SUBJECT: VOGTLE ELECTRIC GENERATING PLANT, UNITS 1 AND 2, ISSUANCE OF AMENDMENT NOS. 210 AND 193, REGARDING REVISION TO TECHNICAL SPECIFICATION 3.3.5, "4.16 KV [KILOVOLT] ESF [ENGINEERED SAFETY FEATURE] BUS LOSS OF POWER (LOP) INSTRUMENTATION" (EPID L-2021-LLA-0054)

SAFETY EVALUATION BY THE OFFICE OF NUCLEAR REACTOR REGULATION

AMENDMENT NO. 210 TO RENEWED FACILITY OPERATING LICENSE NPF-68

AMENDMENT NO. 193 TO RENEWED FACILITY OPERATING LICENSE NPF-81

Figure 1: Vogtle Units 1 & 2 DV and LOV Relay AVs NTSs Relationships and Margins Calculations by NRC Staff

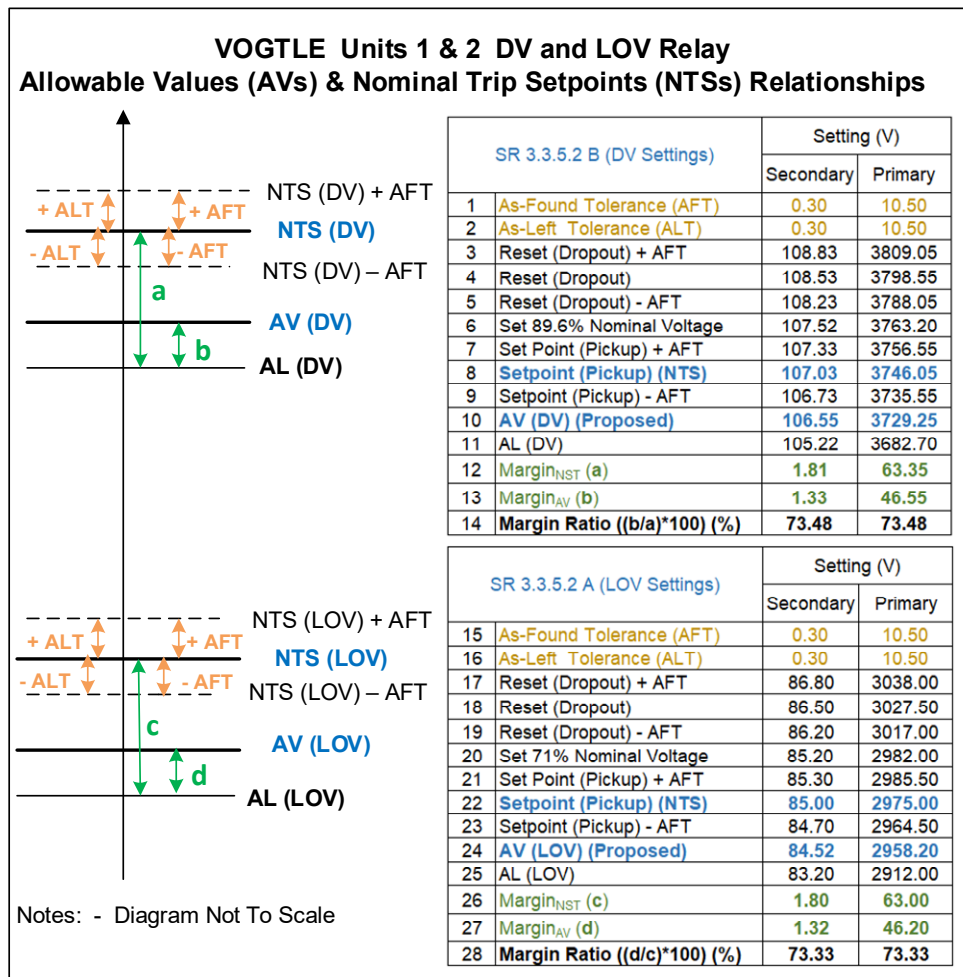
The NRC staff's evaluation and confirmatory results are summarized in Figure 1 below.

- The minimum Reset (Dropout) values of the DV and LOV (Rows 5 and 19) are greater than their maximum Setpoint (Pickup) values (Rows 7 and 21). Therefore, there is adequate separation between the pickup and dropout setpoints.

- The NTSs (Pickup) of DV and LOV inclusive of their AFTs (Rows 9 and 23) are greater than the AVs of DV and LOV (Rows 10 and 24), and therefore, would assure that the trip signals from the DV circuit and/or from LOV circuit would be initiated prior to exceeding their AV values.

- The undervoltage two-out-of-four logic is provided to allow load shedding and tripping of the incoming breaker. These devices are set to operate with a time delay (of  $\leq 0.8$  s for DV and  $\leq 20$ s for LOV (no change)) at the proposed minimum of 89.6-percent (for DV) and 71-percent (for LOV) of nominal voltage. These proposed settings are greater than the minimum settings in Chapter 7 of the Vogtle FSAR (88.5-percent (for DV) and 70-percent (for LOV)). Therefore, the proposed settings would be below the minimum expected voltage during the DG sequencing and would prevent the unwanted tripping and undervoltage induced damage to the safety-related loads.

- The ratio between the NTS and AV margins are greater than 73-percent (Rows 14 and 28) and are adequate. These margins ensure that the trip setpoints have been chosen to assure that a trip or safety actuation will occur well before the measured process reaches the Lower Analytical Limits (Minimum Equipment Acceptable Voltage). Therefore, the proposed AV settings support an automatic protective action before a safety limit is exceeded.

Based on the above, the NRC staff finds that the proposed DV and LOV relay settings (minimum AVs) for SR 3.3.5.2 A and SR 3.3.5.2 B in TS Section 3.3.5 maintain adequate AV margins, consistent with RG 1.105, and continue to satisfy the requirements of GDC 13. The NRC staff further finds the requirements of 10 CFR 50.36(c)(1)(ii)(A) and 10 CFR 50.36(c)(3) will be met, because automatic protective action will correct the abnormal situation before a safety limit is exceeded and the SR will assure that the necessary quality of systems and components is maintained, that facility operation will be within safety limits, and that the limiting conditions for operation will be met. Therefore, the proposed AVs are acceptable.
